**Addendum for Bid**  
**GLTC Operations & Maintenance Facility**  
**15-961**

Date: February 16, 2015  
From: Stephanie Suter, CPPO, CPPB  
RE: Addendum No. 1

Project GLTC O&M Facility Addendum No. 1  
Lynchburg VA Contract \_\_\_\_\_  
Wendel Project No. 444505 Date 2/13/2015

C304

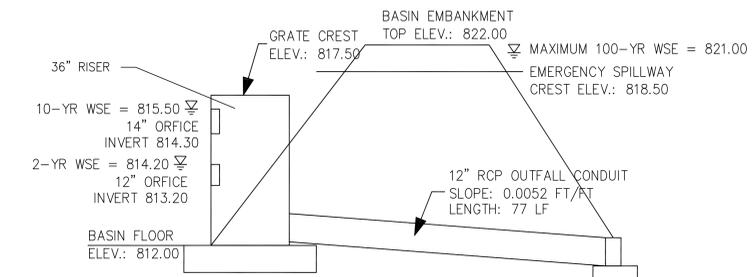
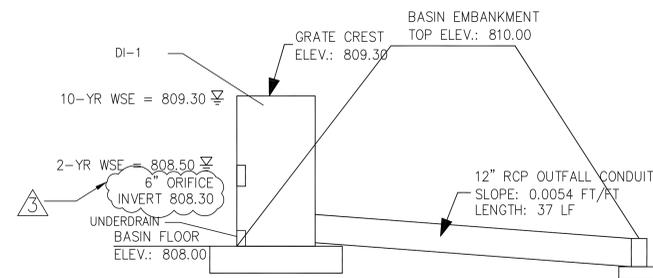
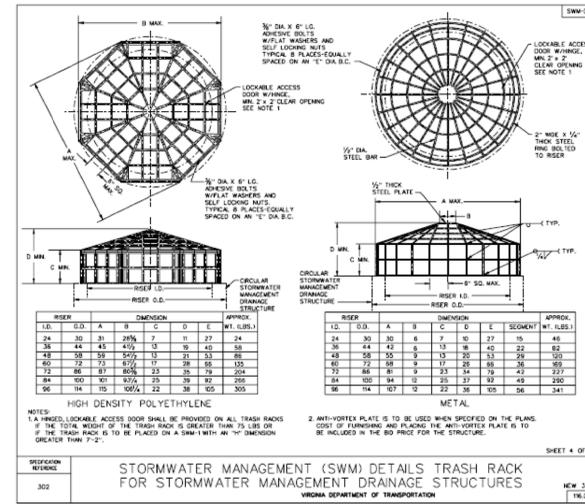
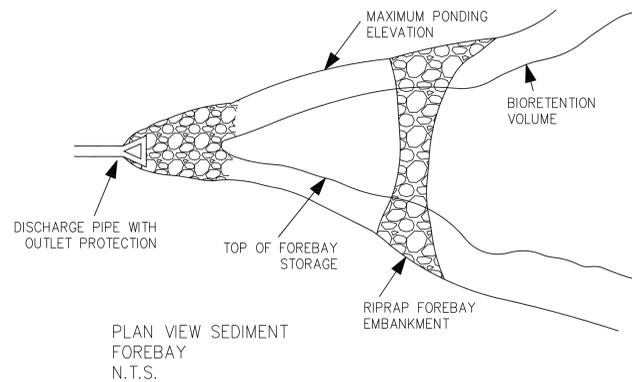
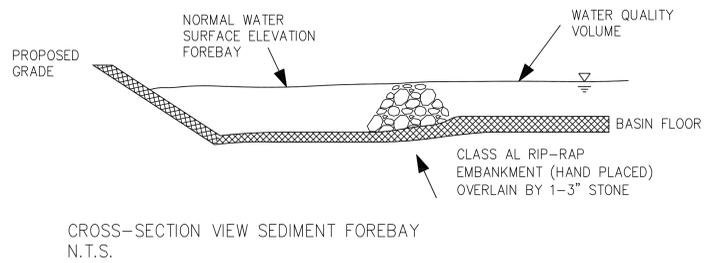
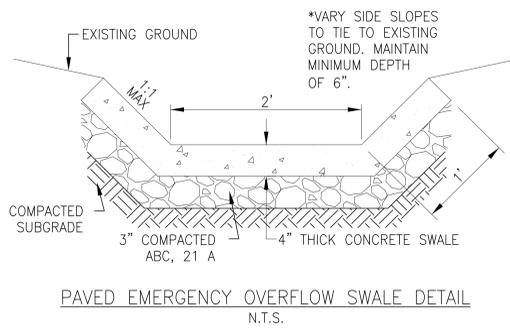
ARTICLE - 6 DRAWING NO. C302, C304,  
Structure GLTC-13 SPEC C501, C501A  
SECTION \_\_\_\_\_

ARTICLE - 7 DRAWING NO. C302, C304,  
Structure GLTC 15 SPEC C501, C501A  
SECTION \_\_\_\_\_

**CLARIFICATION:** The rim elevation on GLTC 13 is at 817.50.

**REVISE:** The table to show an invert on the outfall pipe of 808.00. The orifice from the pond should be a 6" orifice at 808.3. Yes this is to be a standard VDOT DI-1 with trash rack installed.
